ADDENDUM NO.1

Subject: **Addendum No.1 to Contract Documents
City of Mercer Island
2021 Water System Improvements Project (Bid #21-02)**

- 1) Revised Project Specifications: replace Technical Specification page TS-20 with the attached replacement page.
- 2) Revised WA-04: replace plan sheet WA-04 with the attached replacement sheet.

2/23/21
 JOB NUMBER:
20-286
 SHEET NAME:
WA-04
 SHT 13 OF 26

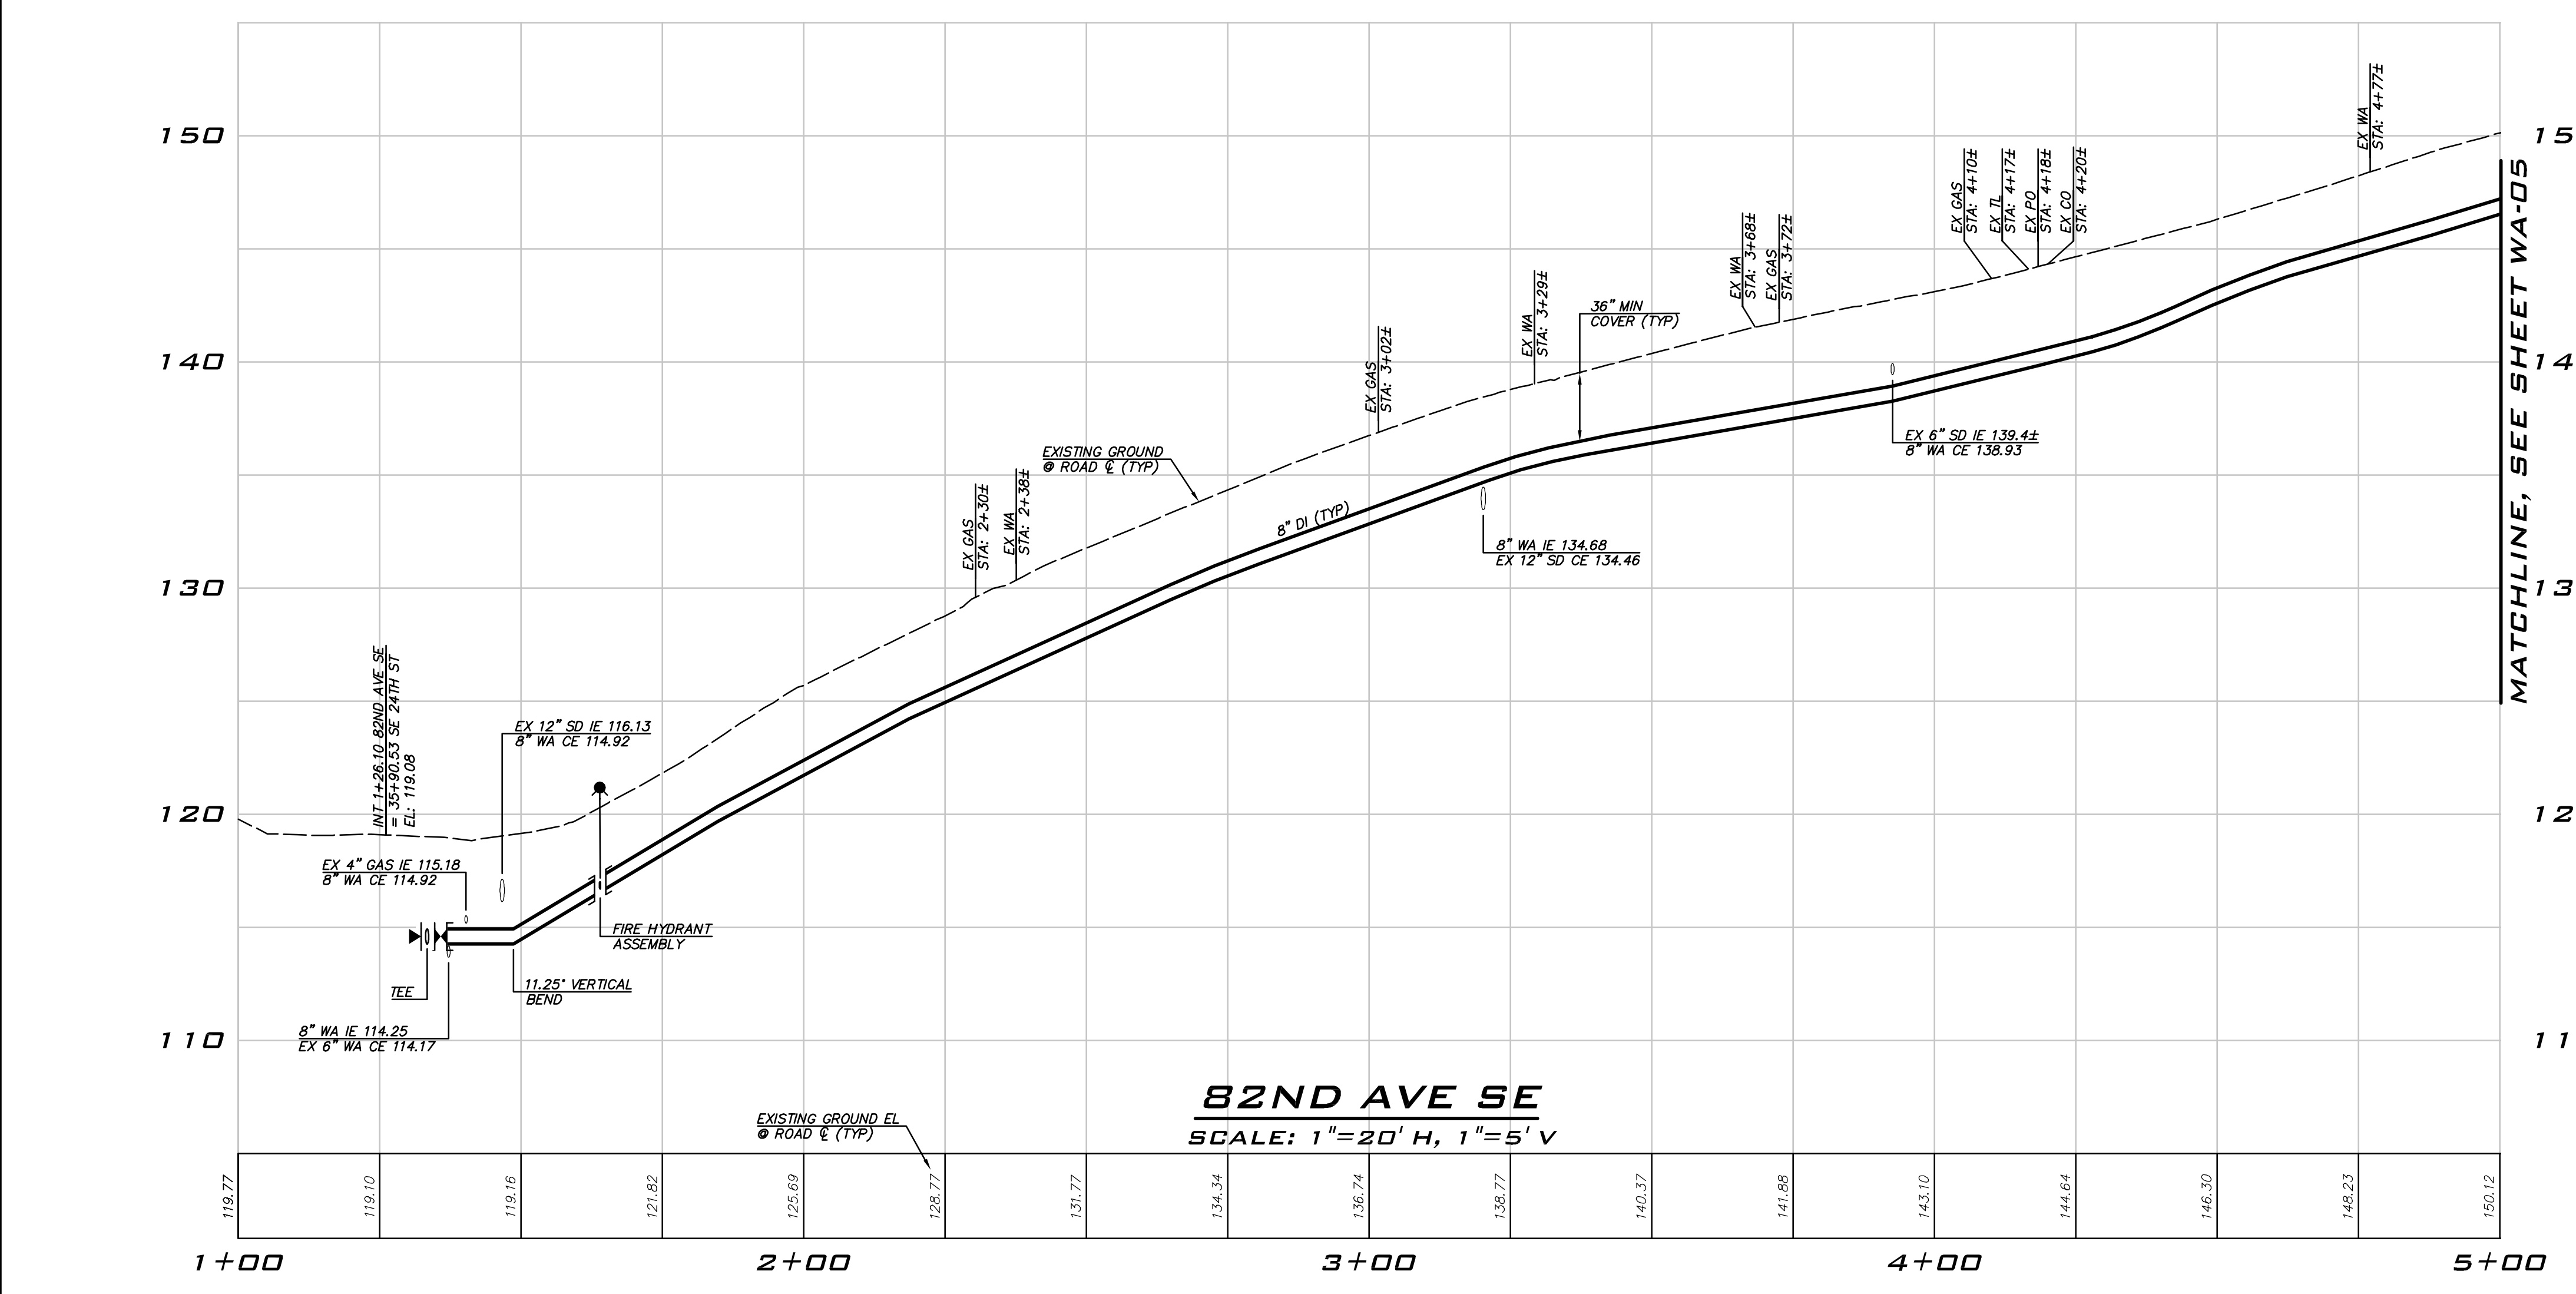
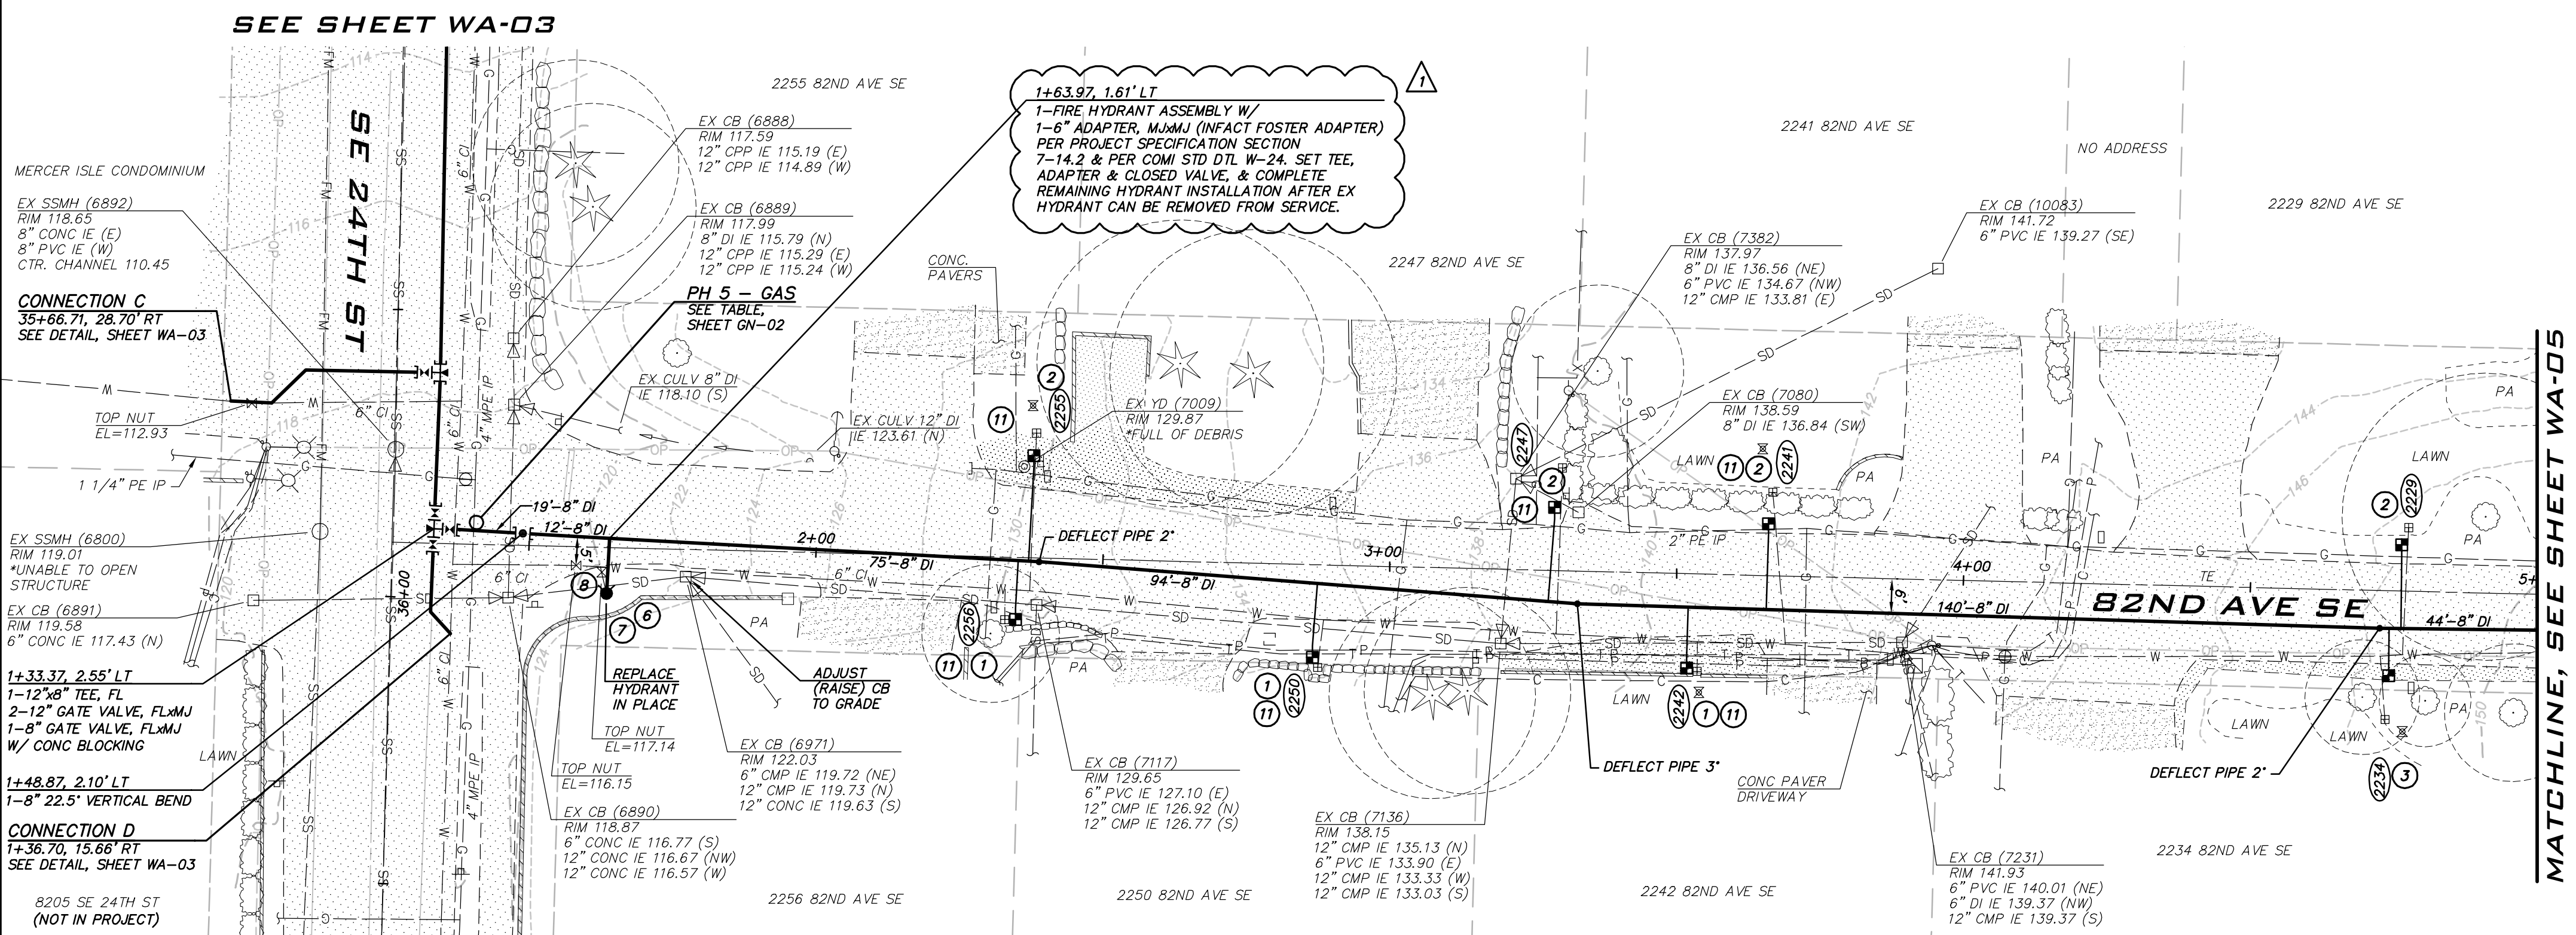
NO	DATE	BY	REVISIONS
1	3/10/21	GD	ADDITIONAL 1
